PO#2602--FOUNTAIN--Gate style #20----- thickness: 2-1/4"

PROWELL WOODWORKS
800.466.1850

Dated: Feb 16, 2026

GATE #1
Exterior Front Left Gate

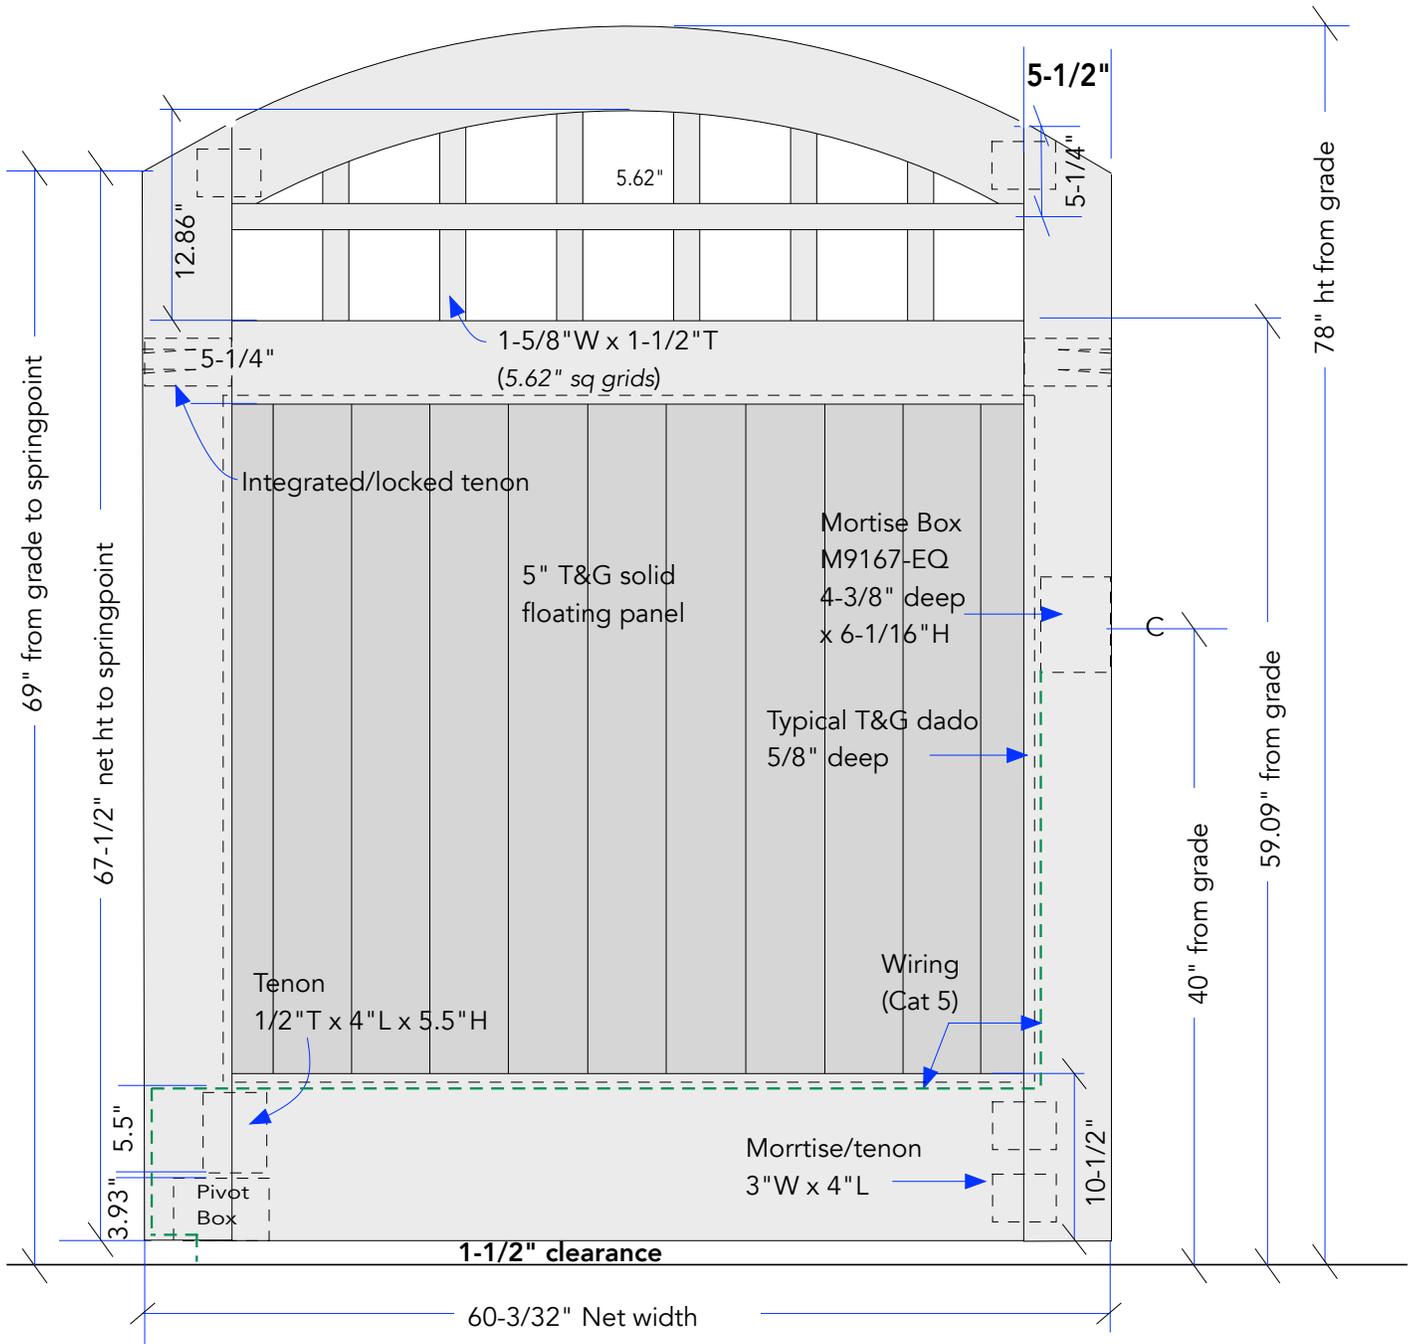
Feb 16 revisions:
* Move lock to 40" from grade

GATE #2
Exterior Front Right Main Gate

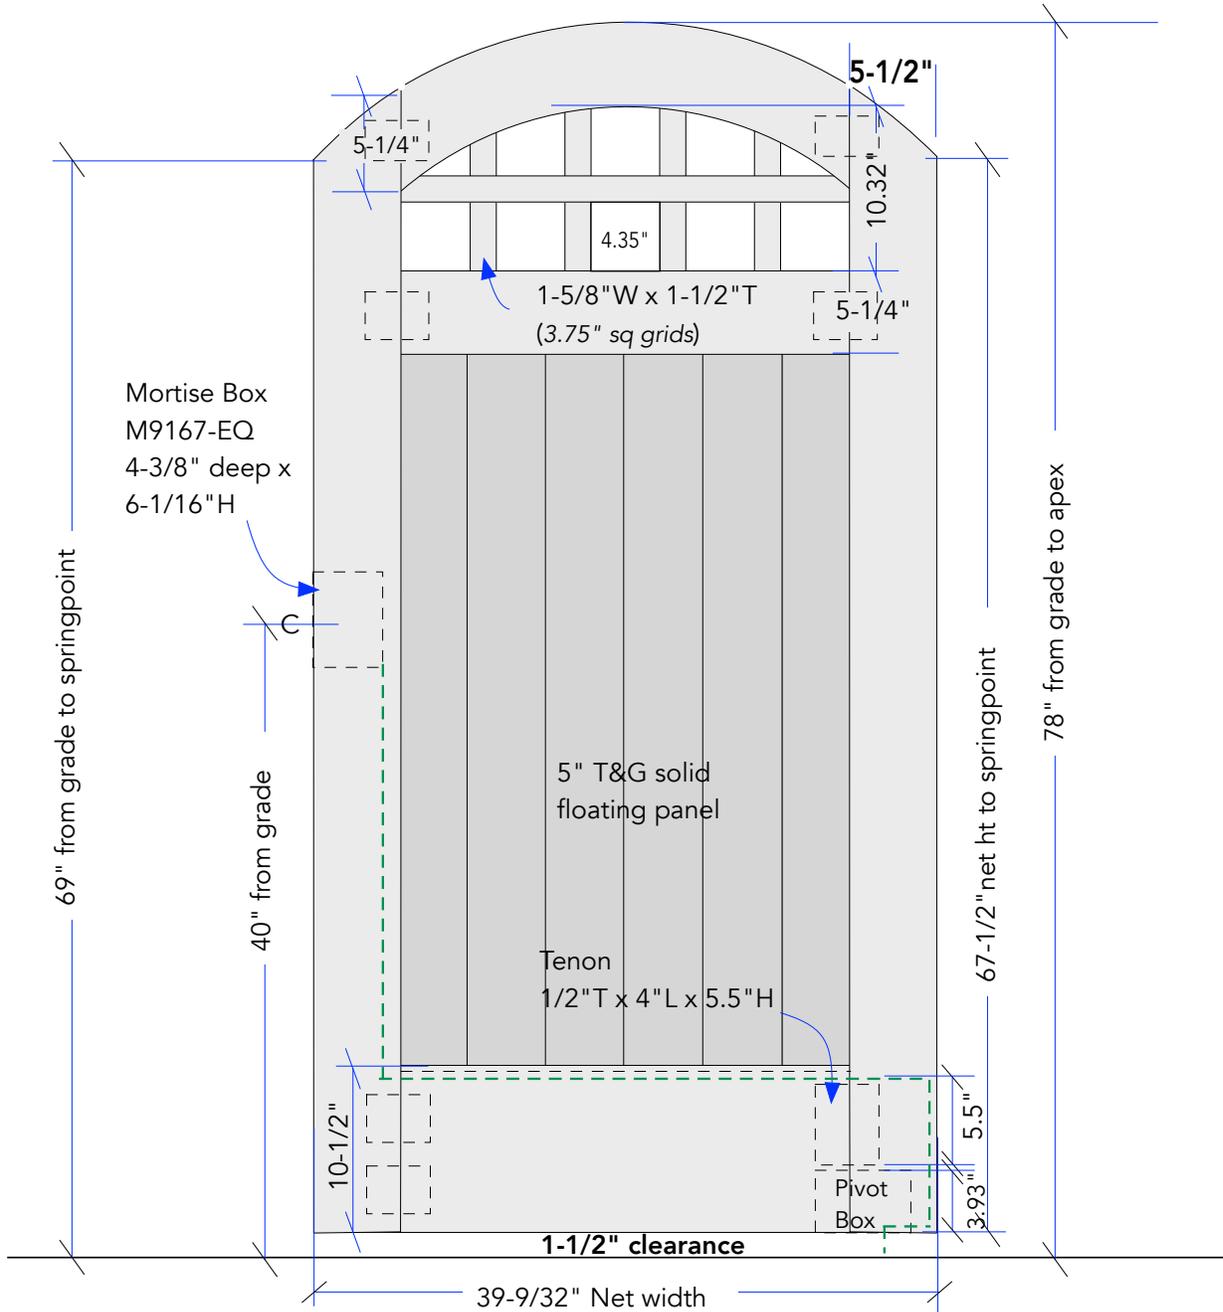
Revisions: 16th
* Lock to 40" from grade
* Show wiring schematic

GATE #3

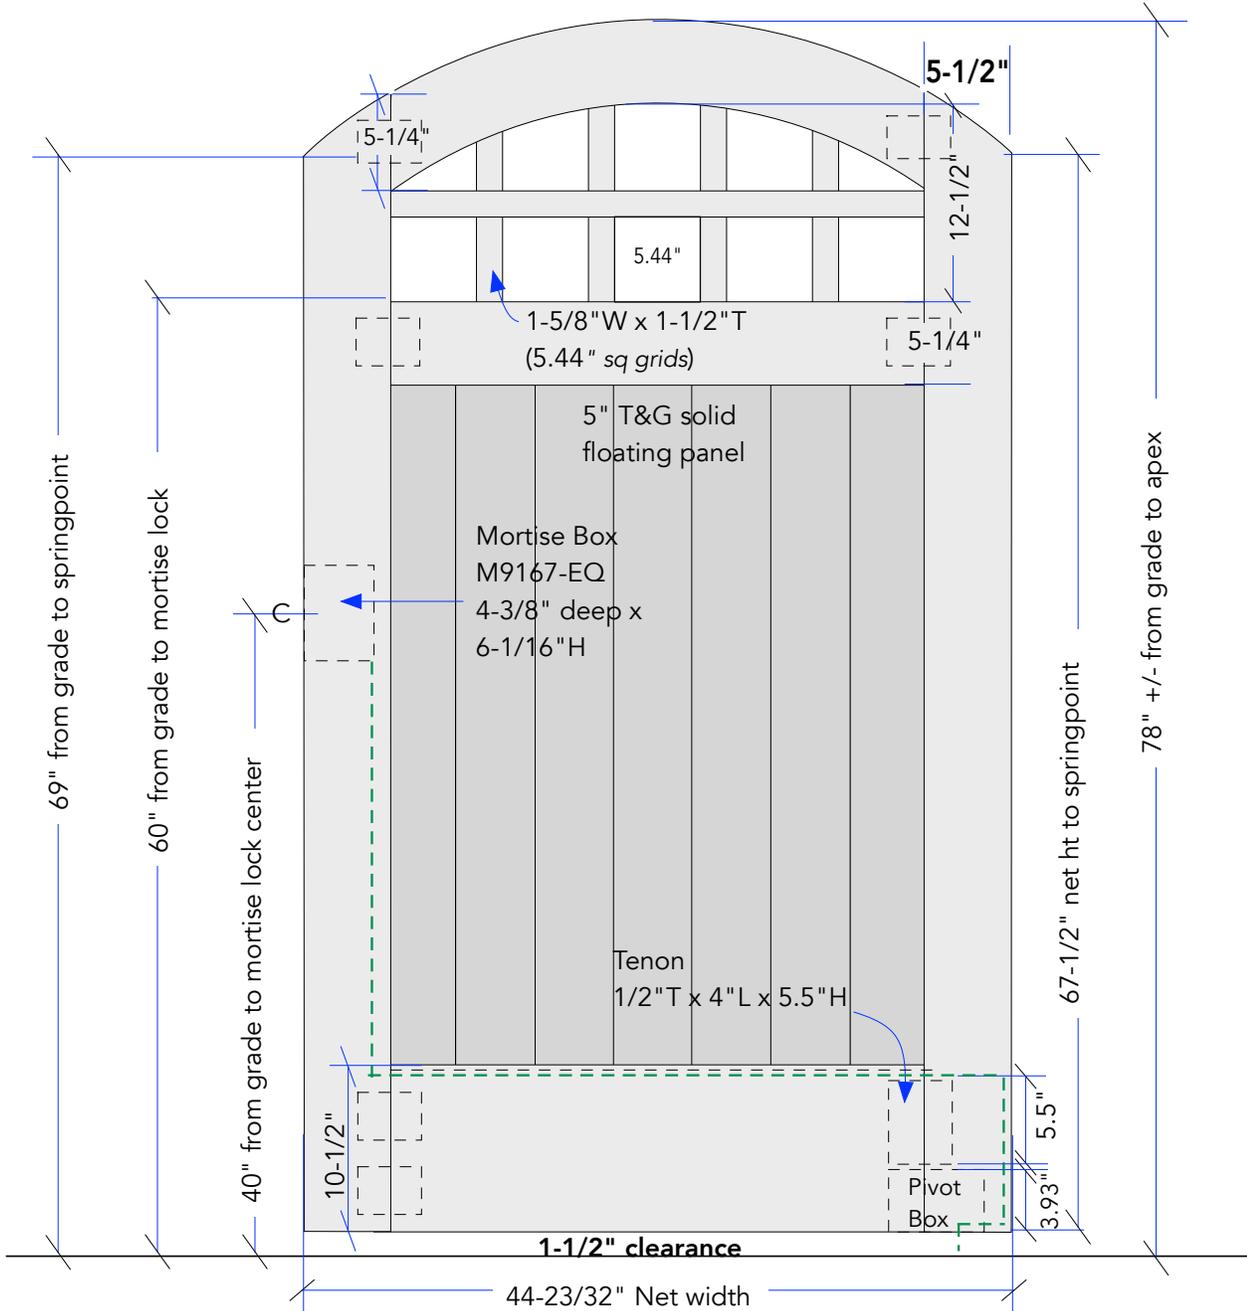
Revisions: 16th

* Lock to 40" from grade

* Show wiring schematic

GATE #4

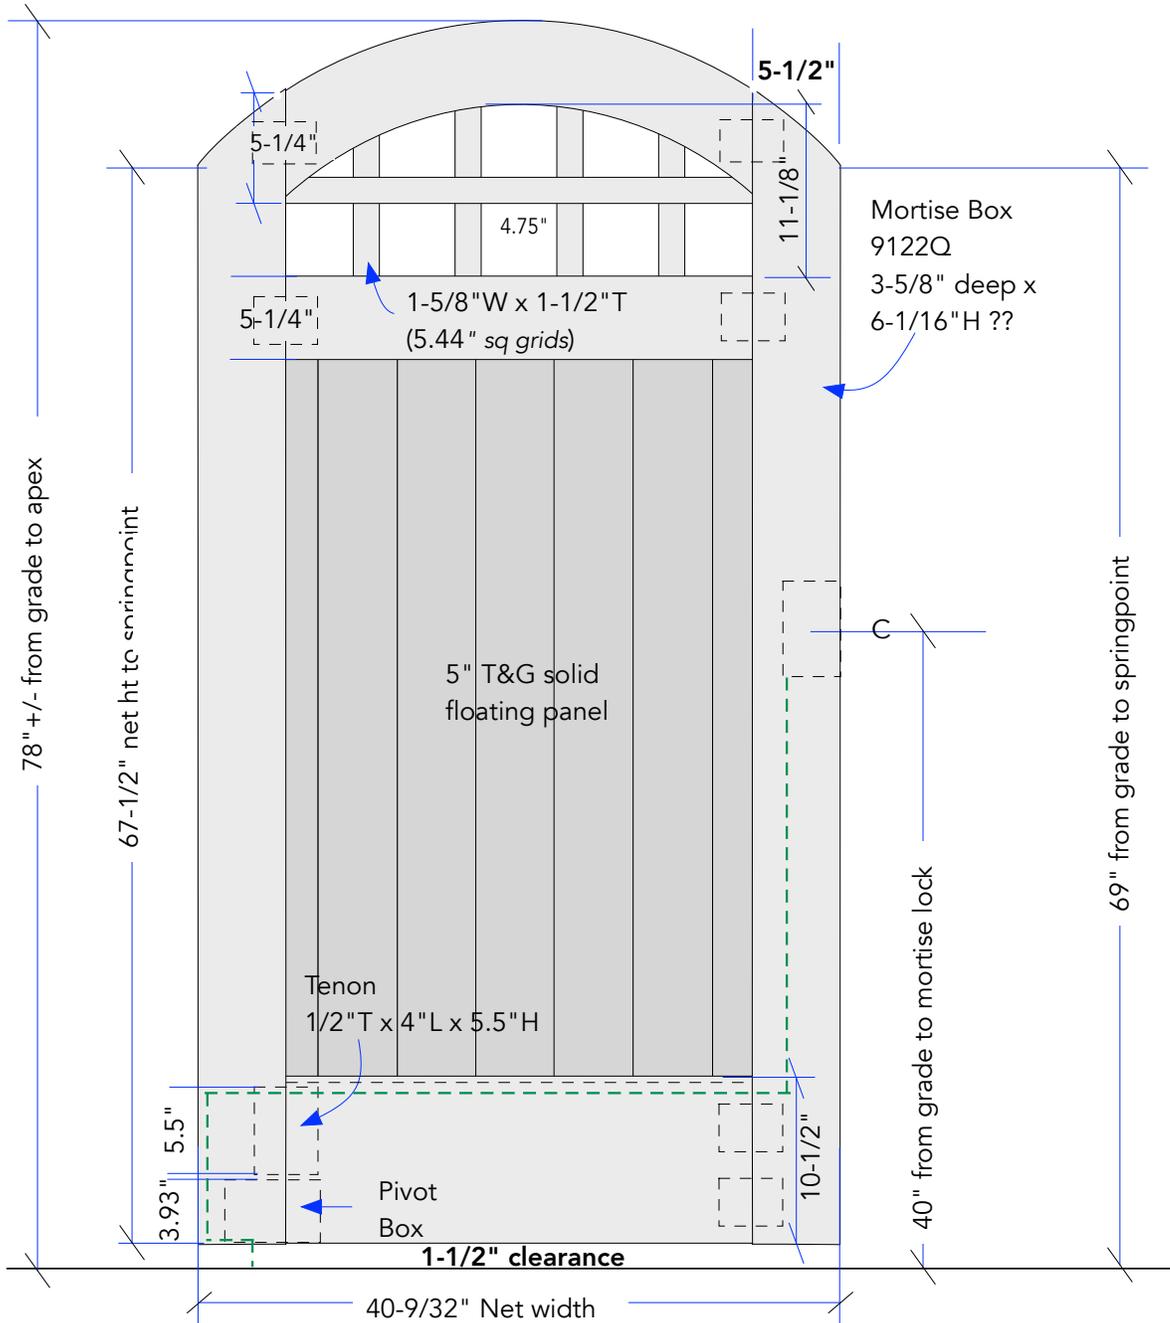
Revisions: 16th

* Lock to 40" from grade

* Show wiring schematic

GATE #5

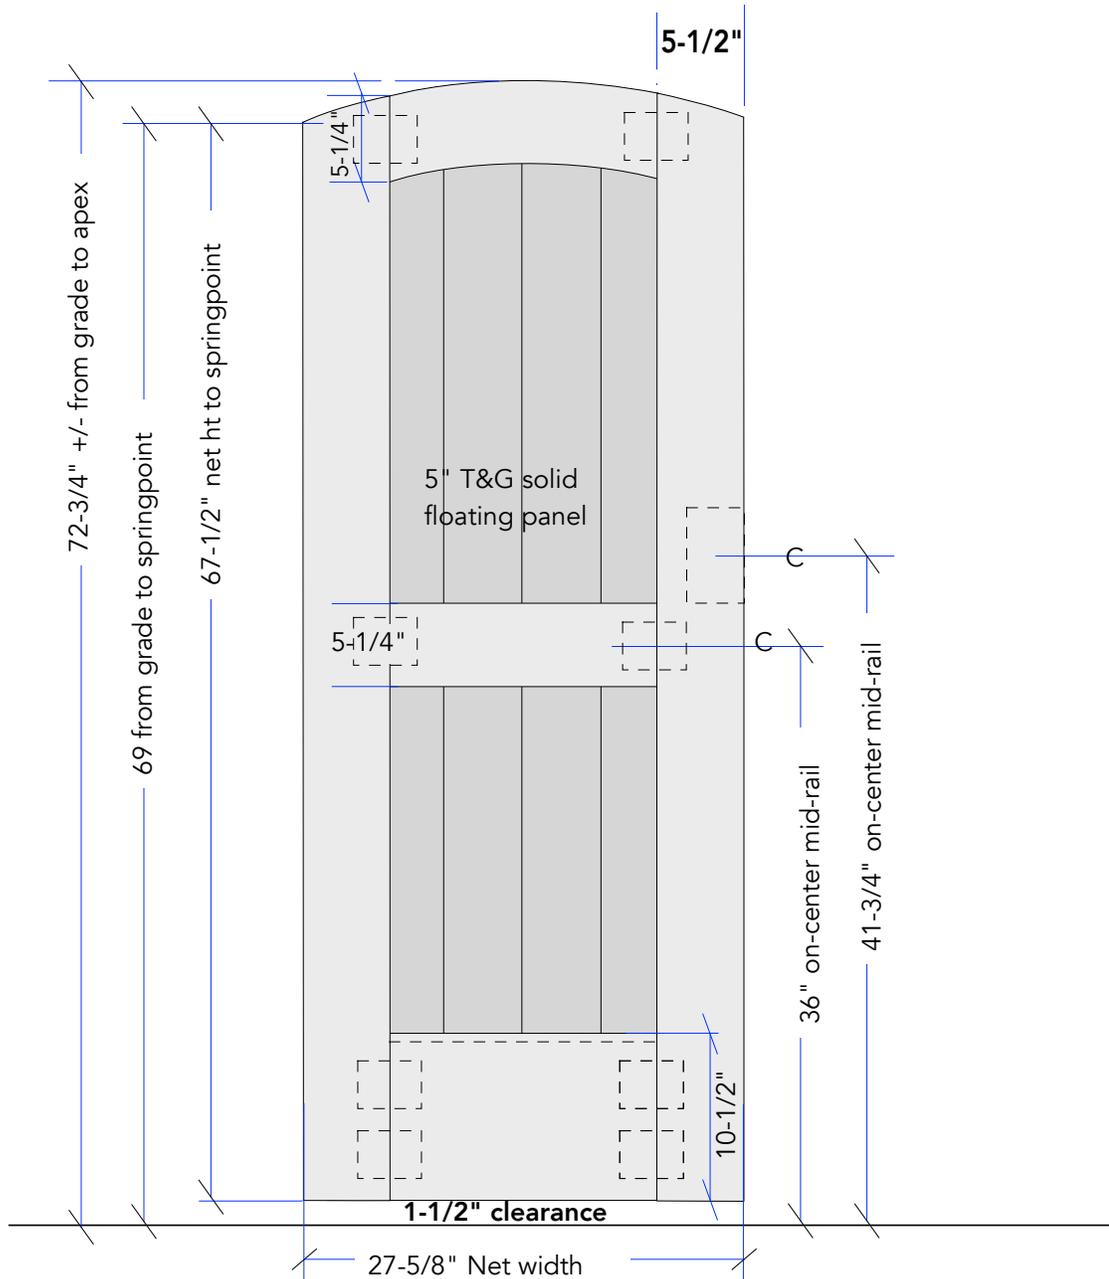
Revisions: 16th

* Grade to apex at 72"

* Show Lock at 41-3/4" from grade

GATE #6

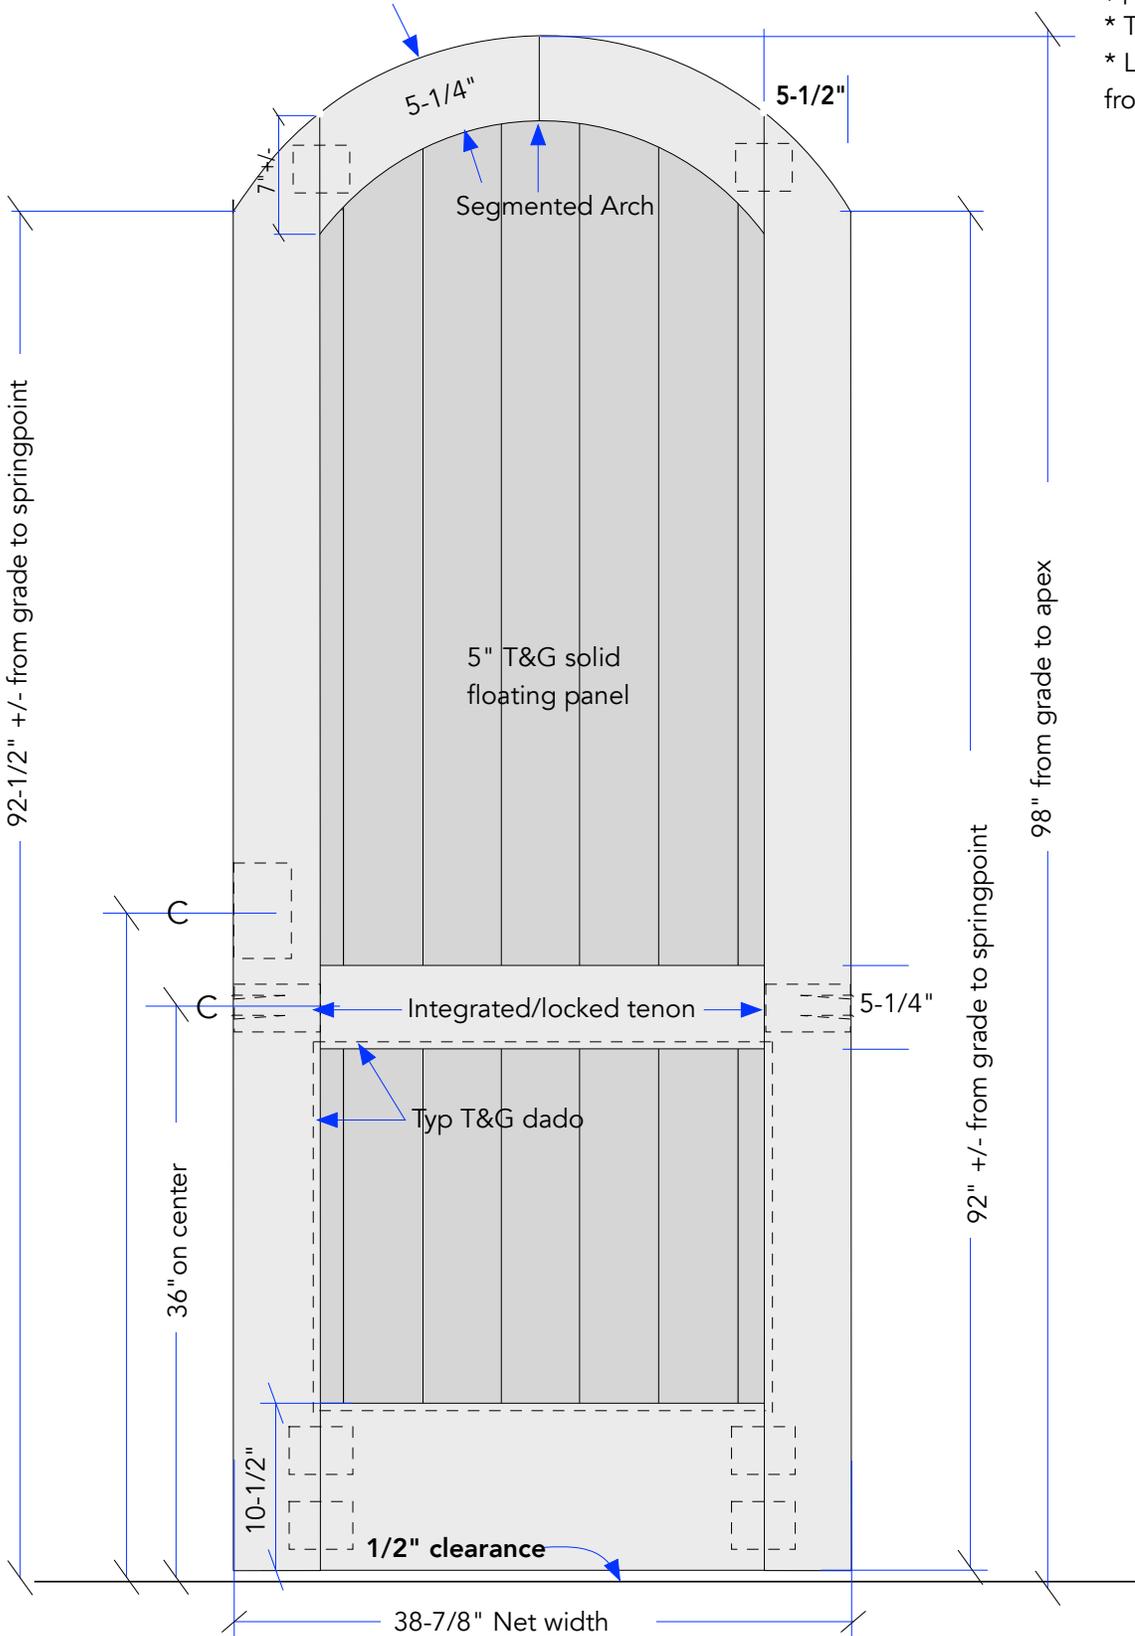
revisions: 16th

* 98" grade to apex

(spring-point unchanged)

* Top arch is segmented

* Lock shown at 41-3/4"
from grade
